File reference: 29B051.00  
TCC reference: RC12837  
Your reference: 850677.002

**Section 92 Request: Tauranga City Council – Slip remediation works to a 4WD track at Pilot Bay, Mount Maunganui**

**Title of Report:** **NON-NOTIFIED APPLICATION FOR DISCRETIONARY AND NON-COMPLYING LAND USE CONSENTS UNDER THE RESOURCE MANAGEMENT ACT 1991 AT 1 ADAMS AVENUE, MOUNT MAUNGANUI**

CLIENT, PROJECT	TAURANGA CITY COUNCIL MAJAO 4WD TRACK
TITLE	RETAINING WALL PLAN - OPTION 4
SCALES (AT A3 SIZE)	1:250
DWG. No.	850677-SK-303
REV.	1

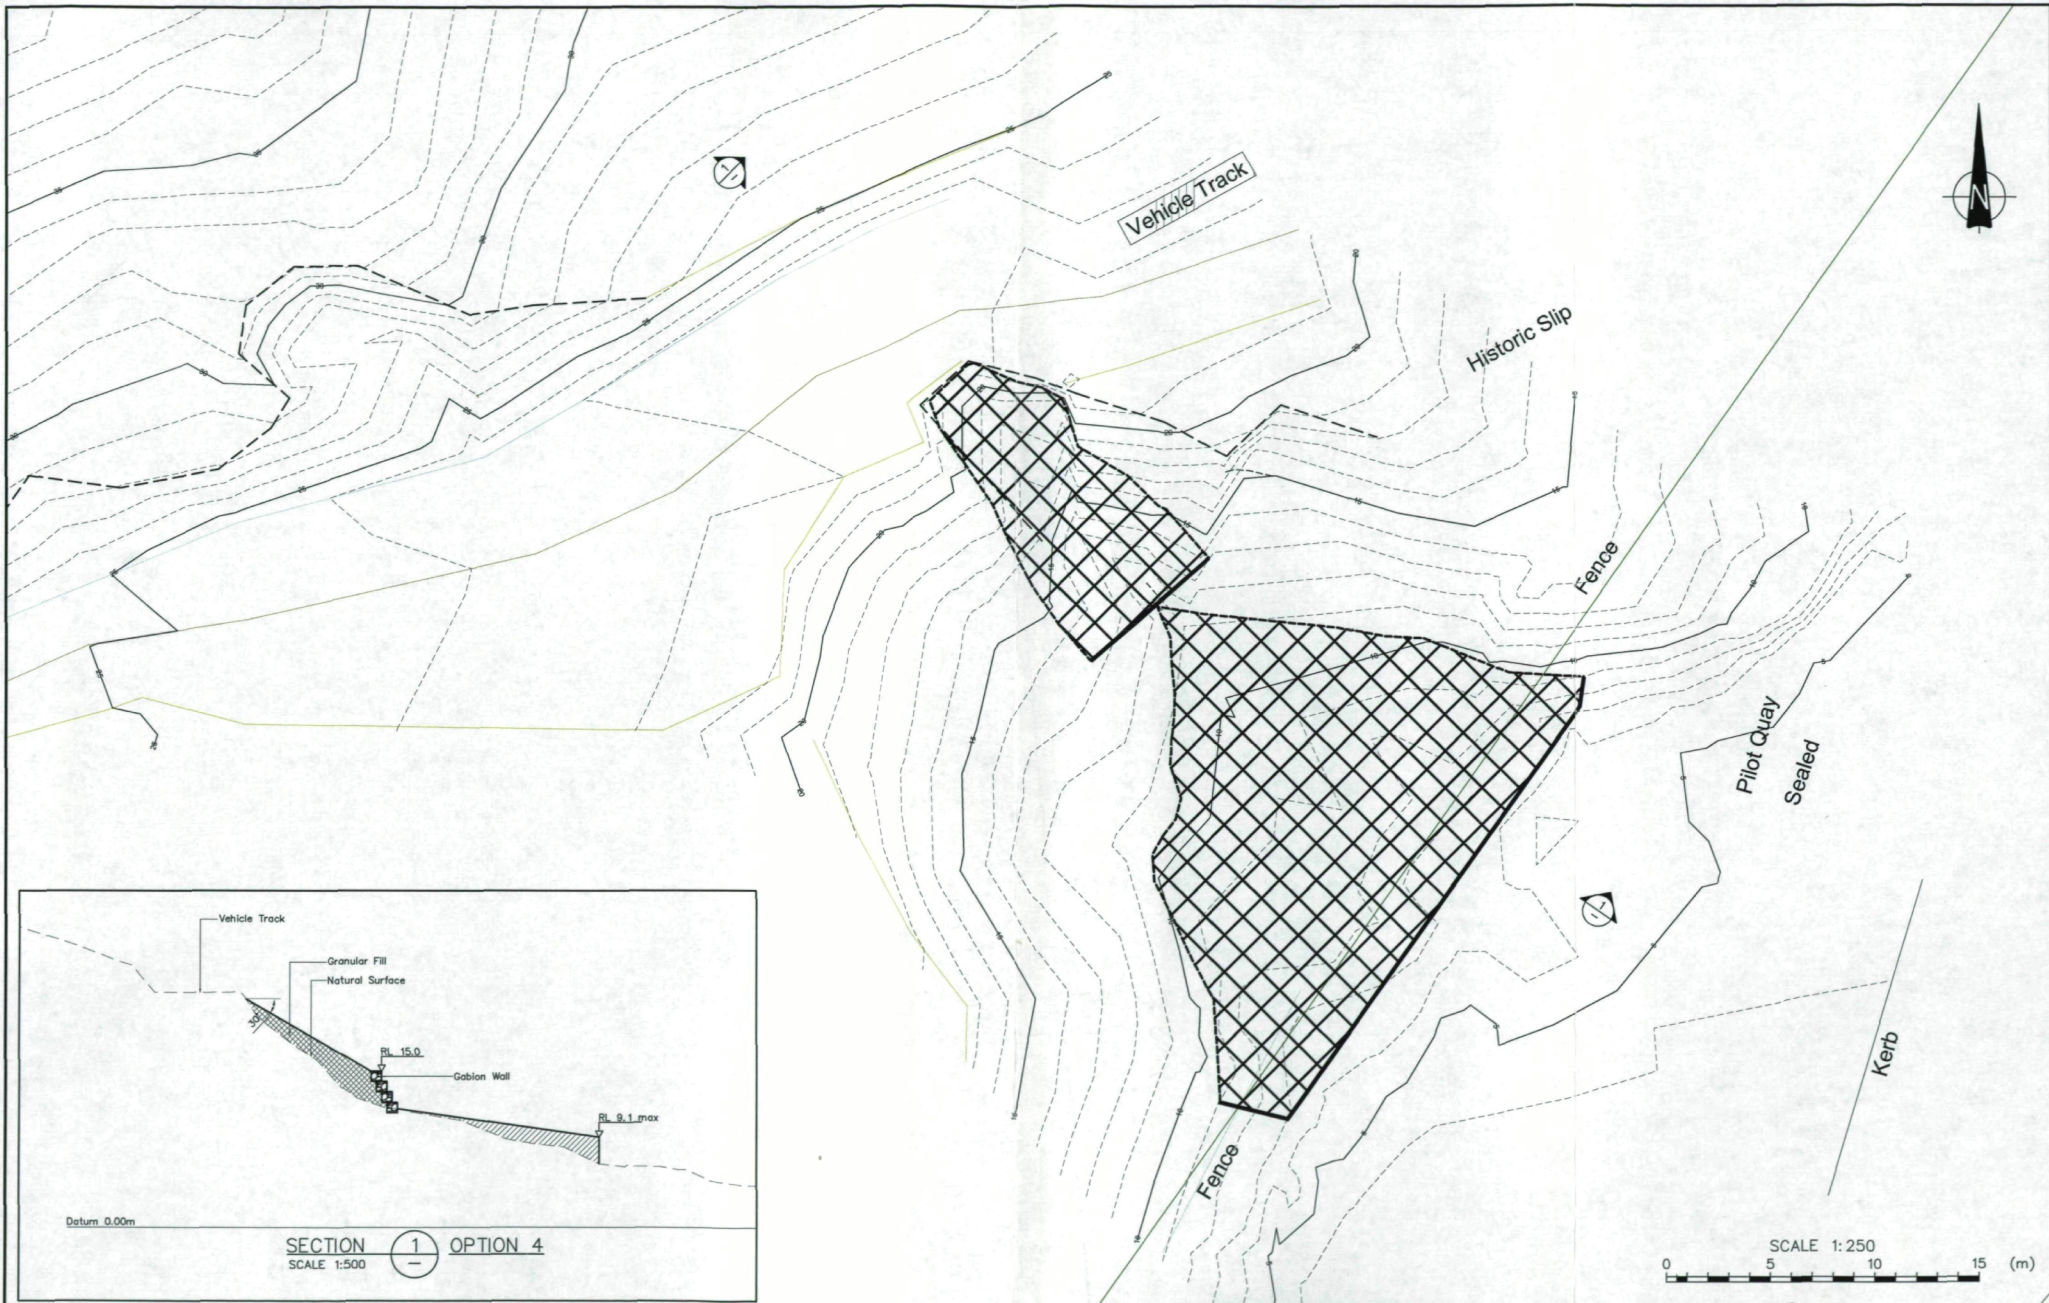
Please provide a description of "small scale earth works", relevant to this application, this should include details on: the area of earthworks and the volume of excavation works that are being proposed and the quantity of material being imported to site.

Also enclosed is a revised plan drawing of the proposed works.

DESIGNED :	Jul.06
DRAWN :	Jul.06
DESIGN CHECKED :	
DRAFTING CHECKED :	
CADFILE :	T:\Tauranga\850677-SK-303
APPROVED :	
<b>NOT FOR CONSTRUCTION</b>	
This drawing is not to be used for construction purposes unless signed as approved.	
REVISION DESCRIPTION	BY DATE
1 Walls revised	
0 First Issue

CLIENT, PROJECT	TAURANGA CITY COUNCIL PILOT QUAY, MAUAO
TITLE	PILOT QUAY SLIP REMEDIATION Site Plan
SCALES (AT A3 SIZE)	1 in 200
DWG. No.	850677/1 - 100
REV.	A

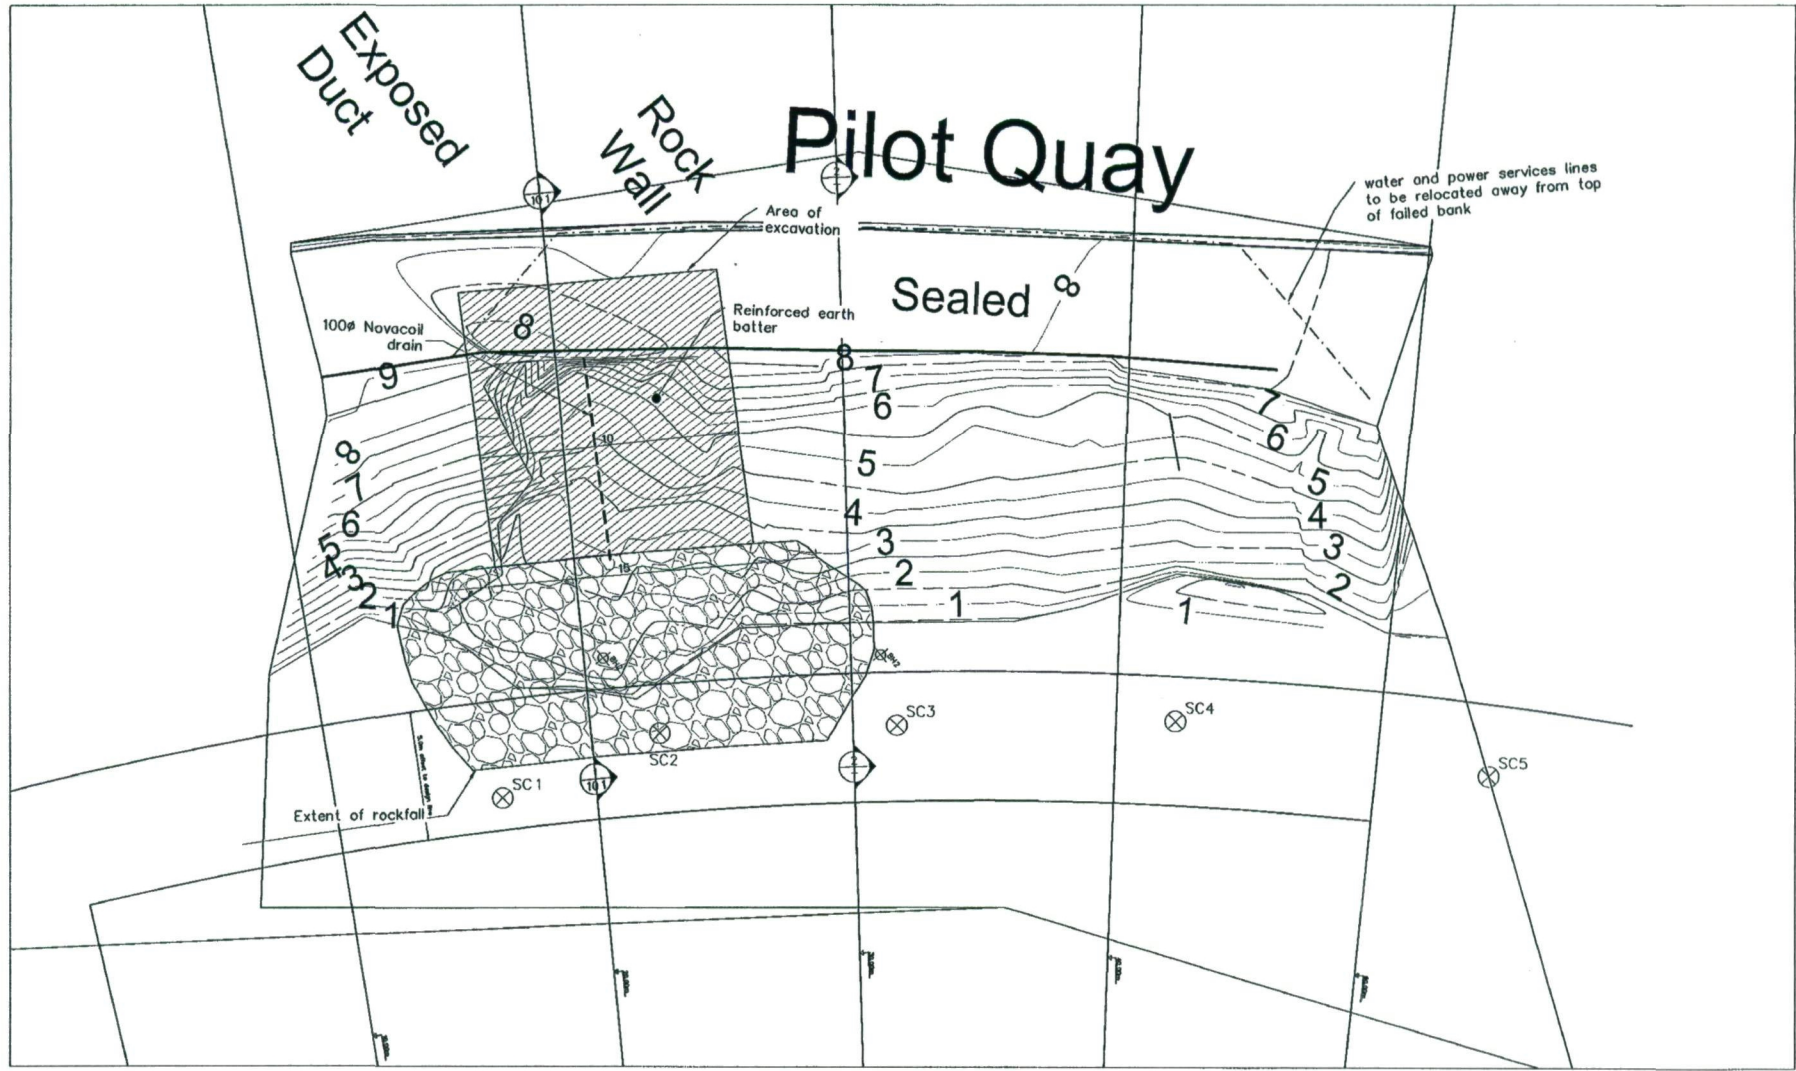
Investigations of the foundation material have been undertaken in the form of Dynamic Cone Penetrometer (scalar) measurements. Locations of these are indicated in the included drawing 100 Rev A. Also included are photocopies of the scala field sheets.

Analyses of scala measurements show competent material suitable for foundation at  $\sim 0.75\text{m}$  -  $\sim 1.0\text{m}$  depth. Foundation of the revetment is noted as being at least 1.0 below surface.

CLIENT, PROJECT	TAURANGA CITY COUNCIL PILOT QUAY, MAUAO	
TITLE	PILOT QUAY SLIP REMEDIATION Cross Section One	
SCALE, (AT A3 SIZE)	1 in 100	DWG. No. 850677/1- 101
REV.	A

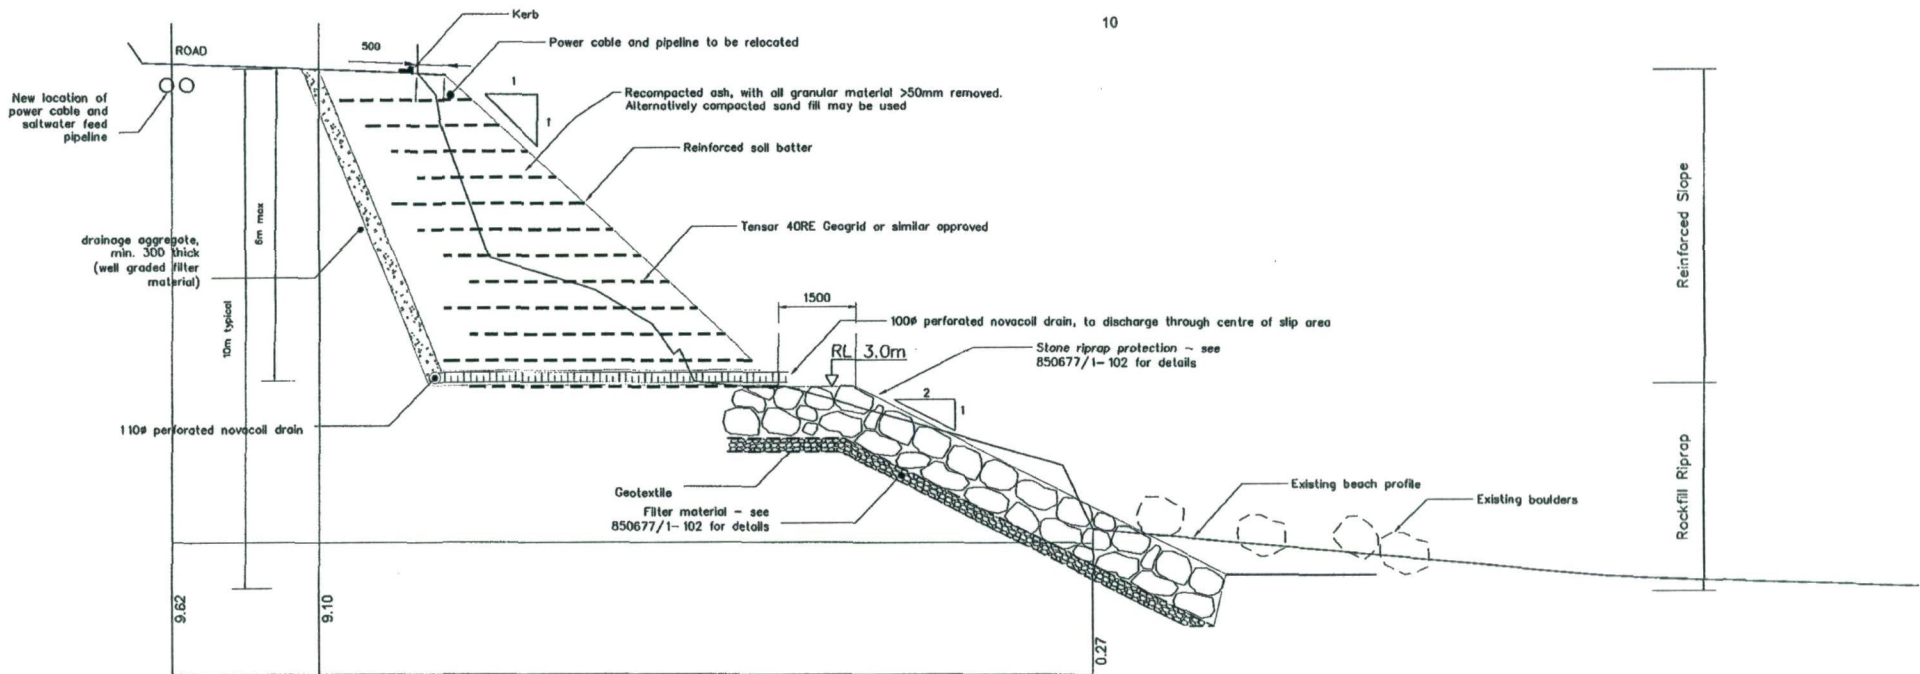
This letter provides a revised revetment design based on calculations to determine a design wave and resulting rock armour size. Information on foundation investigations is also included.

From the above calculations a rock armour size of  $D_n(50) = 0.433\text{m}$  with a range of 0.40 m to 0.65 m has been determined. These changes have been included in revised drawings 101 Rev A and 102 Rev A.
